HISTORIC AND DESIGN REVIEW COMMISSION

HDRC CASE NO: 2017-286

ADDRESS: 1127 S ST MARYS

TYPE OF WORK: Driveway installation, landscaping

1 ELEVATION: NEW 4' HIGH STEEL WIRE FENCE
SCALE: 1/2" = 1'-0"

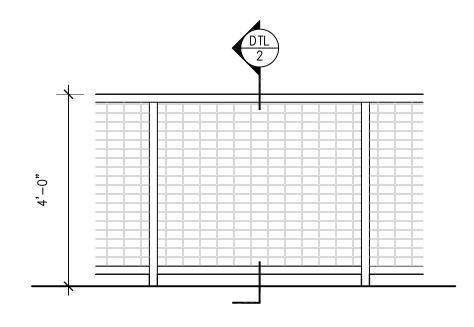
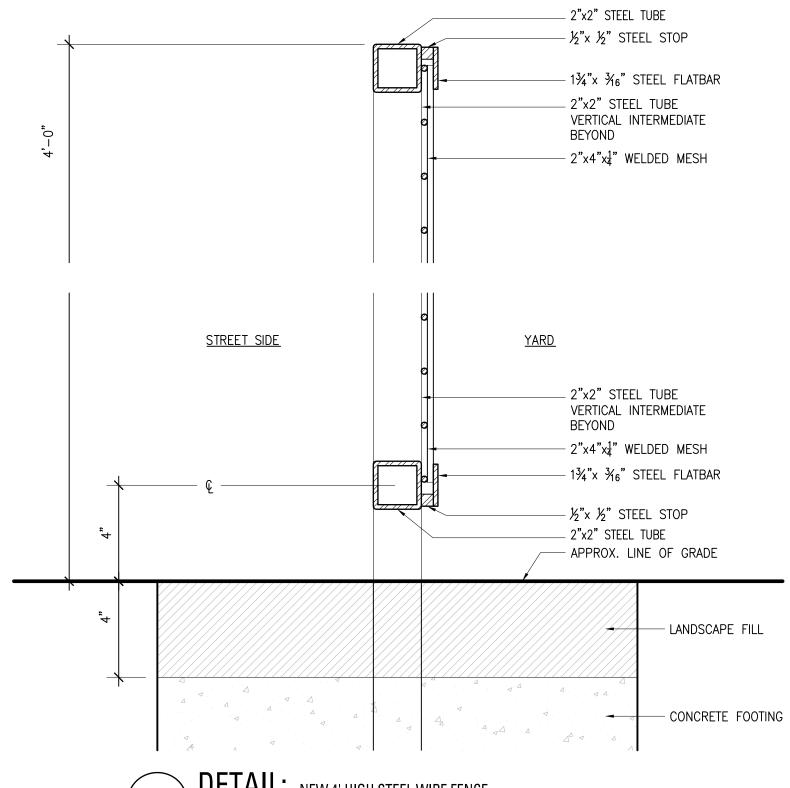
- e. FENCING The applicant has proposed to install front yard fencing to feature four (4) feet in height that is to run throughout the front of the lot to separate the rear of the property from the front. The applicant has proposed materials that include steel tubing and welded mesh. Staff finds these materials to be appropriate for the architectural style of the structure on the lot.

Staff recommends approval as submitted based on finding a through e.
